## MEMORANDUM

**To:** Montgomery Township Zoning Board of Adjustment

**Re:** **Renard Management, Inc.**  
**Use Variance, FAR Variance, Major Site Plan Review #2**  
1026 County Road 518  
Block 29002, Lots 49 and 50  
HC Highway Commercial District

**Date:** November 22, 2023, Revised to March 28, 2024

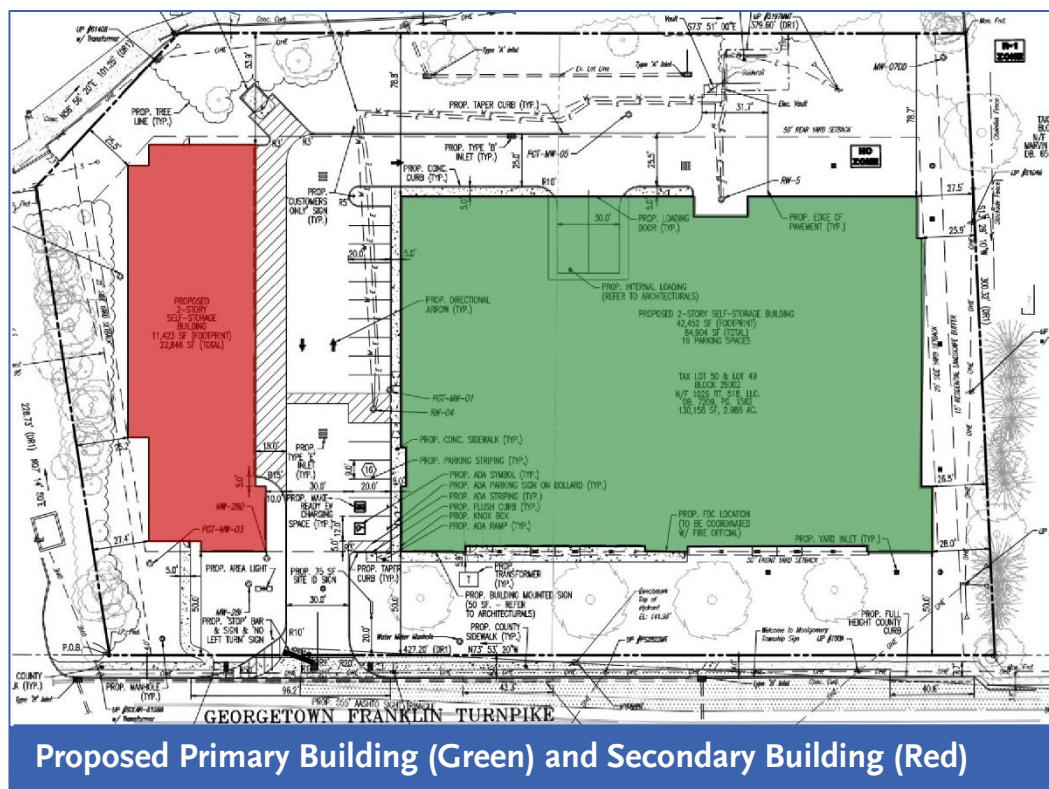
4.1.1. **Building Separation:** *The plan complies.* Pursuant to §16-4.12.e.9(b)(2), all buildings shall be separated by a minimum of 50 feet where the separation distance is used to any extent for parking and/or vehicular circulation. The buildings are separated by 70 feet, and the area of separation is utilized for parking spaces, a driveway and a loading area for the drive up self-storage building.

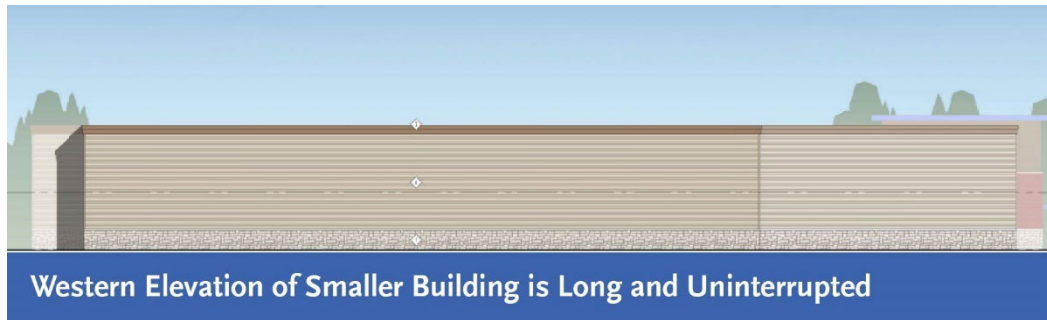
- 10.6. **Pedestrian Scale:** *The plan complies.* §16-4.12e.1(b) requires that architectural details, style, color, proportion and massing shall create a pedestrian scale development. The building has been designed with an effort to create a pedestrian scale. The facades are articulated, and include element such as awnings, windows, doorways, columns, pediments, and stone veneer to create visual interest. The attempt appears to be to create the appearance of a building or building(s) that look like something other than a storage facility, which was the request of this office in our previous letter. The plan appears to comply.
